ADDENDUM 02

Project Name: South King Fire Administrative Building Improvements
Owner: South King Fire
Issued by: Lauren Rock, Weinstein A+U
Issue Date: May 15, 2025

SOUTH KING FIRE ADMINISTRATIVE BUILDING IMPROVEMENTS

1 LEVEL 1 FIRE PROTECTION PLAN
SCALE: 3/16" = 1'-0"

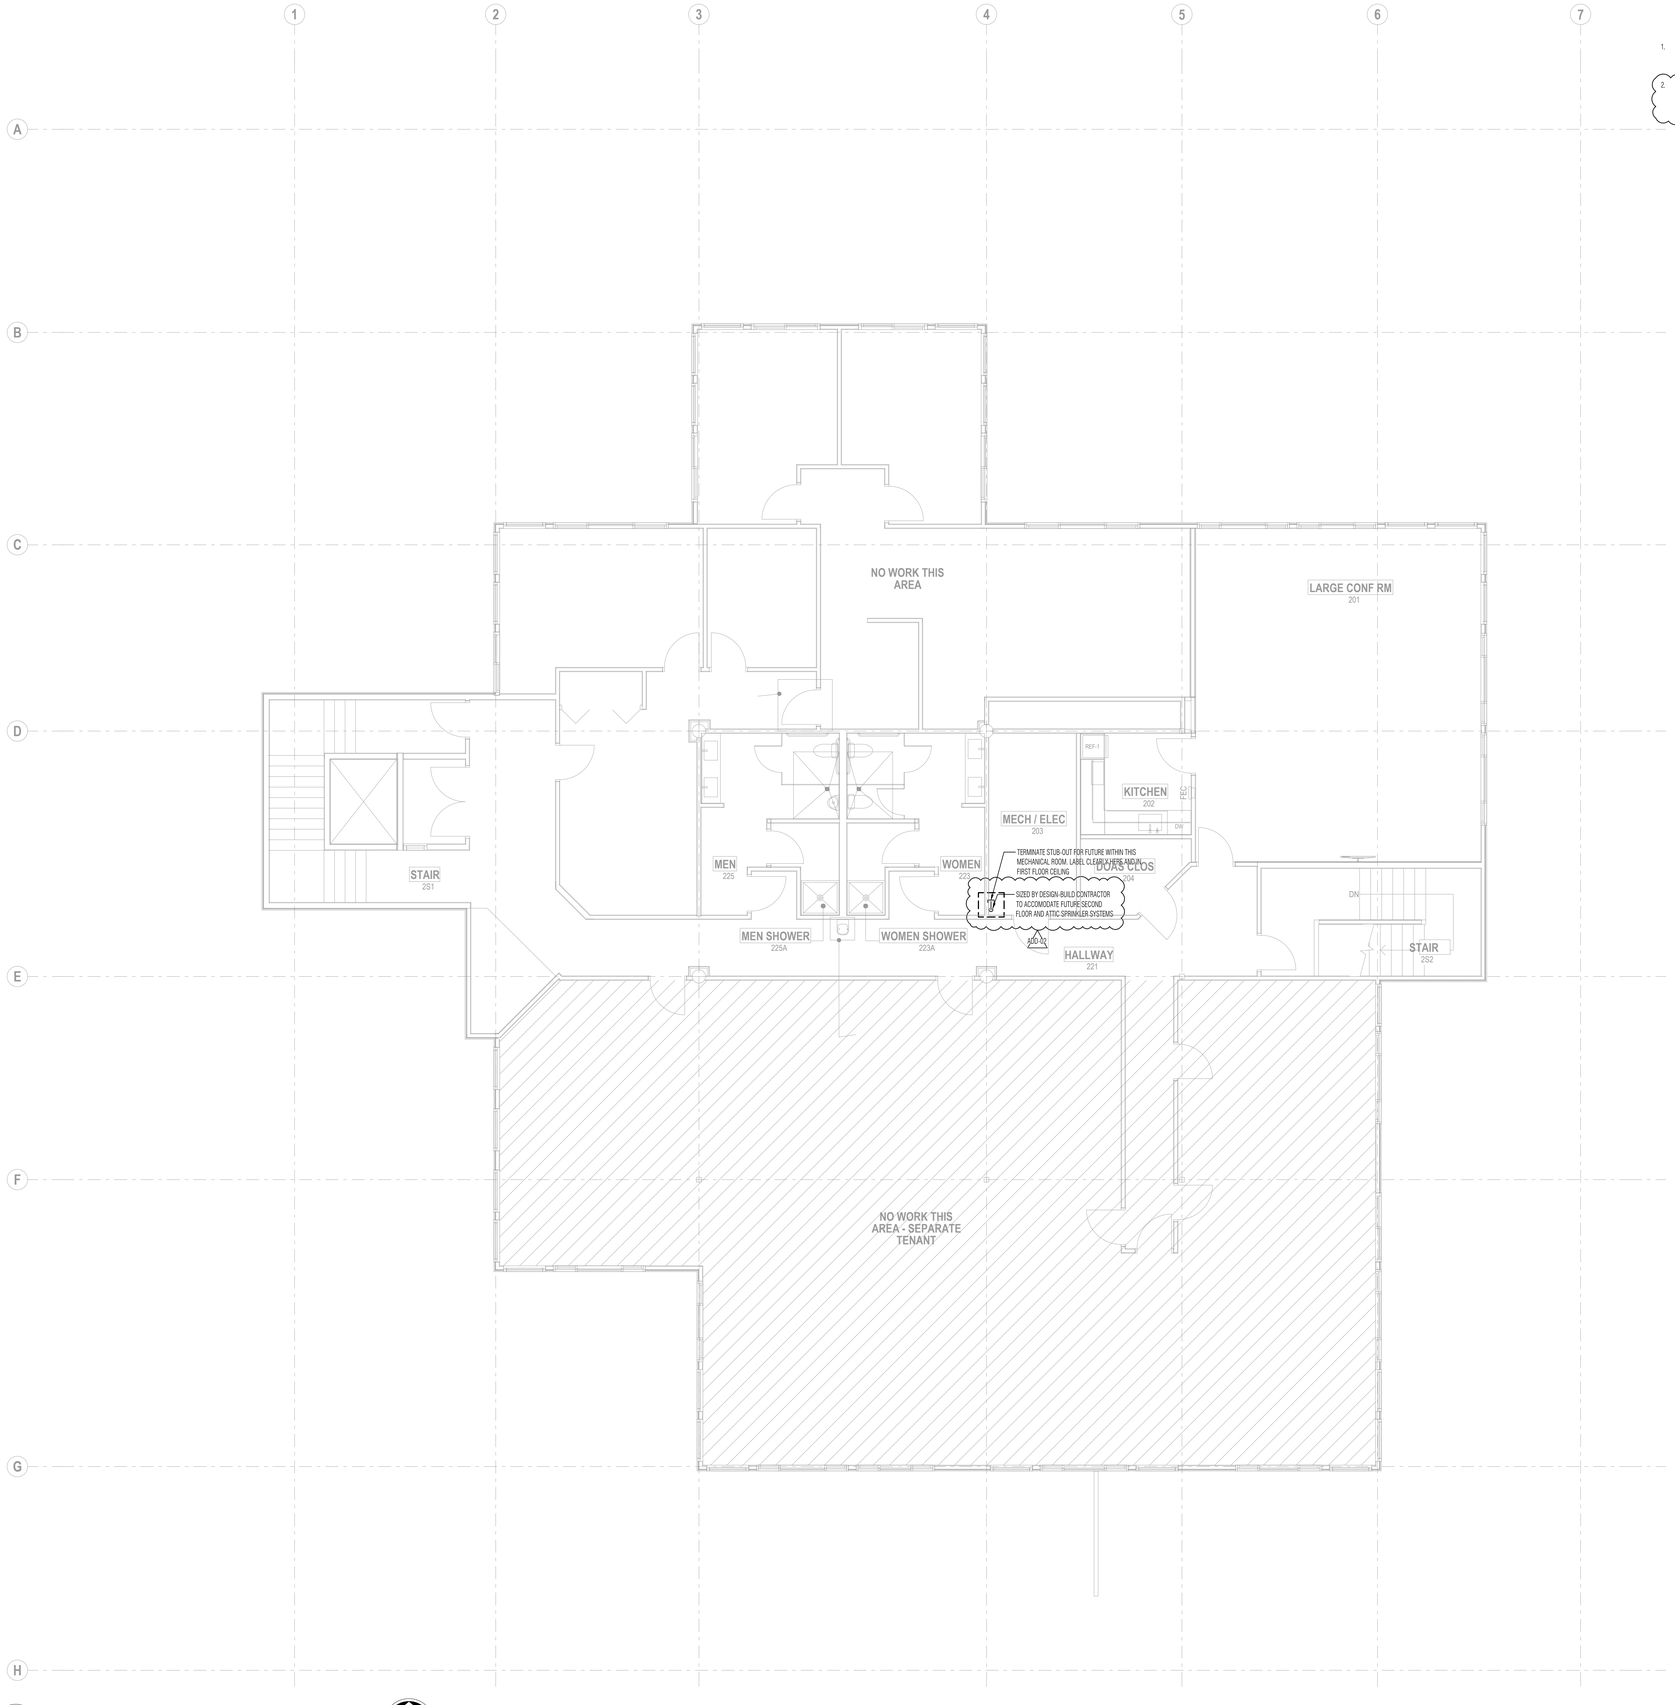
F100	Added Sheet Note 2 to clarify sizing and scope.
F101	Revised notes to clarify sizing and scope.
F102	Revised notes to clarify sizing and scope.

05. Question: Drawing F102 shows a 2” pipe stubbed up to the 2nd floor, this is a small pipe to supply Level 2 for future, are you sure you just want a 2” pipe?

06. Question: Typically, in a building like this the Attic would be protected with fire sprinklers, I see no mention of providing fire sprinkler during this renovation or any future renovations.

Answer: The 2" note is incorrect. Size should be determined by the fire sprinkler designer as part of their scope. See revised F100, F101, F102.

Answer: Size the extension to the second floor, the main branch on the first floor, and the basement riser(s) to accommodate a full attic and full second floor sprinkler system in the future. See revised F100, F101, F102.

1. PIPING IS DIAGRAMMATIC. PROVIDE FITTINGS AND OFFSETS AS REQUIRED TO AVOID WORK OF OTHER TRADES AND AS REQUIRED FOR A CODE COMPLIANT INSTALLATION.
2. DRAWING SHOWS APPROPRIATED SIZE AND ROUTE FOR MAIN PIPES BUT NOT ASSOCIATED BRANCH PIPES. SIZES ARE ESTIMATES AND FINAL SIZING WILL BE BY THE DESIGN-BUILD CONTRACTOR. ADD-02

1 PROVIDE OVERSIZED MAIN OF SECONDARY MAIN AND RISER TO THE UPPER FLOOR TO ACCOMMODATE FUTURE EXPANSION OF THE SYSTEM TO THE SECOND FLOOR AND ATTIC.
REFER TO FOLLOWING PAGE FOR AREAS SERVED BY POSSIBLE FUTURE EXPANSION.
INCLUDE ALL PROVISIONS NEEDED FOR EXPANSION OF THE SYSTEM TO THE SECOND FLOOR AND ATTIC.
TERMINATE STUB OUT IN SECOND FLOOR MECH ROOM CEILING. ADD-02
